SERVICE BULLETIN

No. 304

Piper Aircraft Corporation

Subject: Stall Strip Inspection

(For stall strip part number application refer to sketch on page 3 of this bulletin.)

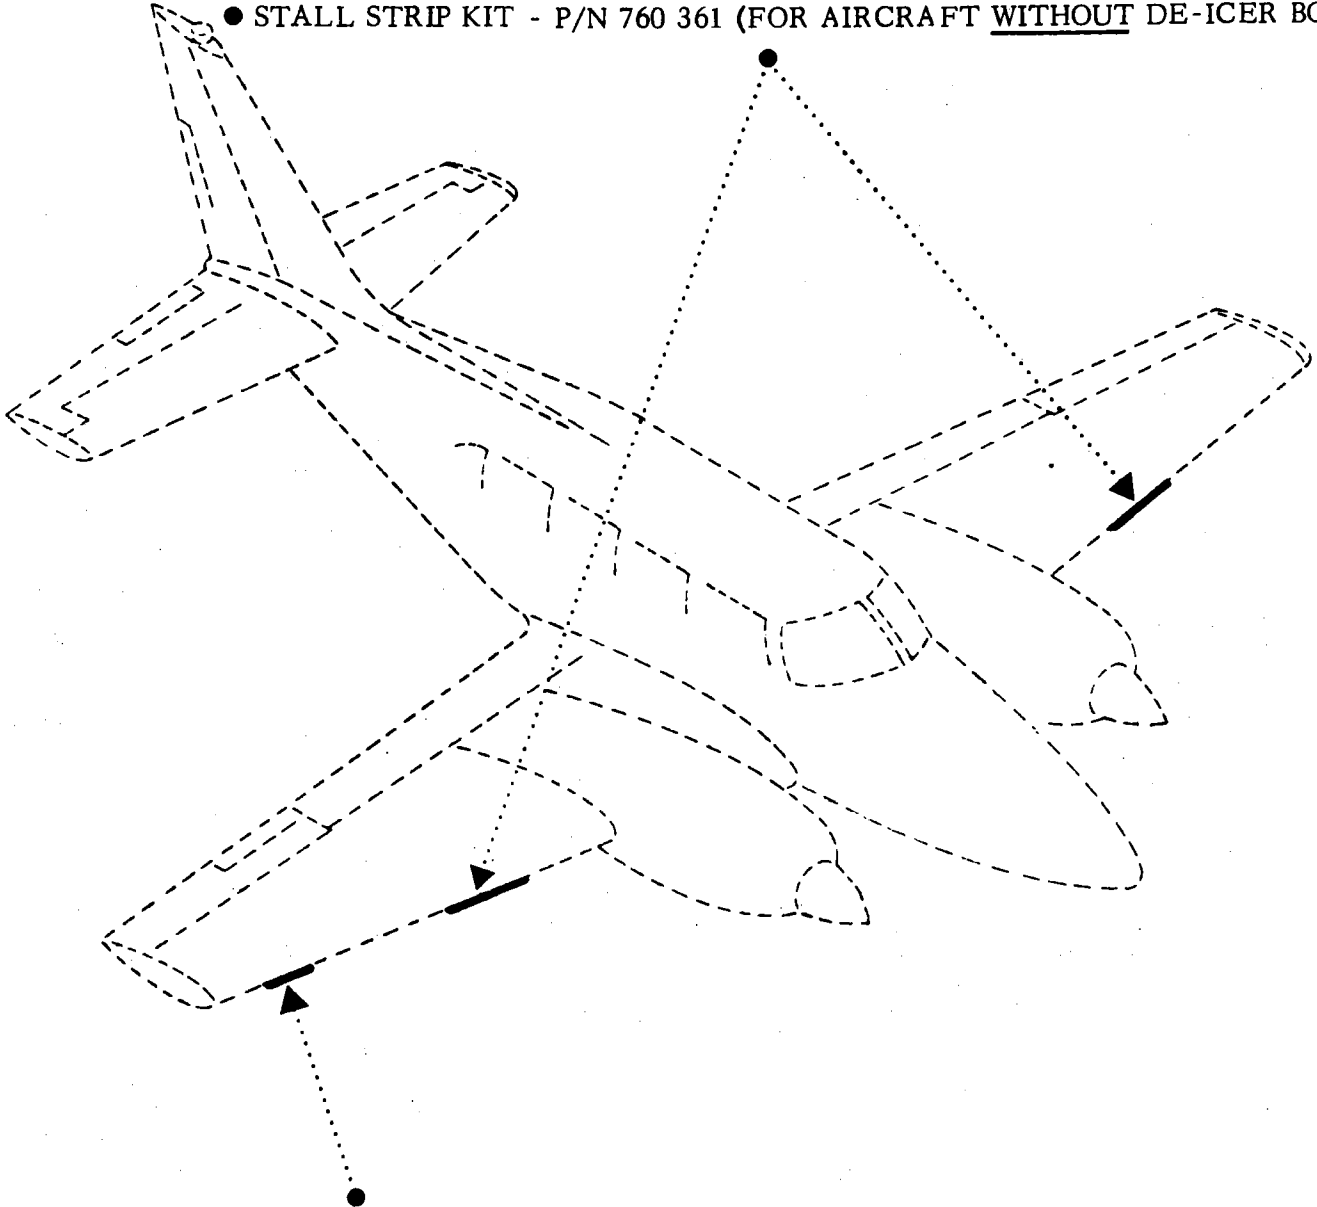
- STALL STRIP - P/N 44275-03 (FOR AIRCRAFT WITH DE-ICER BOOTS)
- STALL STRIP KIT - P/N 760 361 (FOR AIRCRAFT WITHOUT DE-ICER BOOTS)

- STALL STRIP - P/N 44275-05 (FOR AIRCRAFT WITH DE-ICER BOOTS)
- STALL STRIP KIT - P/N 760 362 (FOR AIRCRAFT WITHOUT DE-ICER BOOTS)

A. Aircraft with Wing DeIcer Boots installed: If, during the relocation (if necessary) of the existing stall strips, it is necessary to replace one or more of the presently installed stall strips, the required replacement stall strips are to be ordered from the factory on an emergency AOG basis per Material Required, below.

B. Aircraft without Wing DeIcer Boots: If the above referenced inspection reveals that the existing stall strips must be relocated, it will be necessary to replace the existing stall strips with a Stall Strip Replacement Kit (one kit for each stall strip replaced), per Material Required, below. These stall strip replacement kits are to be ordered from the factory on an emergency AOG basis.
